# UNITED STATES PATENT AND TRADEMARK OFFICE

APPLICATION NO.	FILING DATE	FIRST NAMED INVENTOR	ATTORNEY DOCKET NO.	CONFIRMATION NO.
10/791,997	03/02/2004	Daniel J. Coster	APL1P290/P3186	4300
22434	7590	05/30/2006	EXAMINER	
BEYER WEAVER & THOMAS LLP			PAPE, ZACHARY	
P.O. BOX 70250			ART UNIT	PAPER NUMBER
OAKLAND, CA 94612-0250			2835

**Office Action Summary**

### **DETAILED ACTION**

**Fig 1**

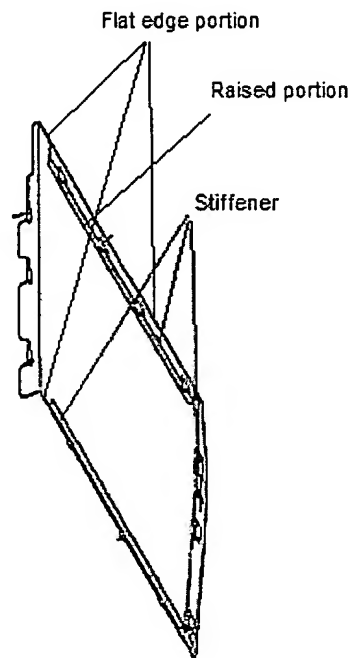
With respect to claim 38, Chen et al. further teaches a stiffener (See present office action Fig 1 below) that is attached to an inner surface of the planar access door, the stiffener being configured for insertion into a recess within the access opening when the access door covers the access opening.

With respect to claim 45, Chen et al. further teaches that the removable access door (80) includes interior and exterior surfaces, the interior surface having a flat edge portion and a raised portion inside the flat edge portion (As illustrated in present office action Fig 1 above).

to edge of the planar panel (As illustrated in POA Fig 1 above, the inner and outer surfaces are flat from edge to edge), and a stiffening member attached to the inner surface of the planar panel (The stiffener is folded over from the edge of the panel), the placement of the stiffening member forming the flat edge portion and raised portion of the removable access door (As illustrated in POA Fig 1 above).

With respect to claim 56, Chen et al. in view of Lin et al. teaches the limitations of claim 35 above, and Chen et al. further teaches that the removable access door (80) includes a planar panel with flat surfaces extending end to end (See POA Fig 1 above) but both Chen et al. and Lin et al. are silent as to they material from which the planar panel and housing are formed. Ahn teaches the conventionality of making both a cover and a housing of aluminum (Paragraphs 53, and 60). It would have been obvious to one of ordinary skill in the art at the time the invention was made to combine the teachings of Ahn with that of Chen et al. and Lin et al. to provide an easily manufacture-able chassis.
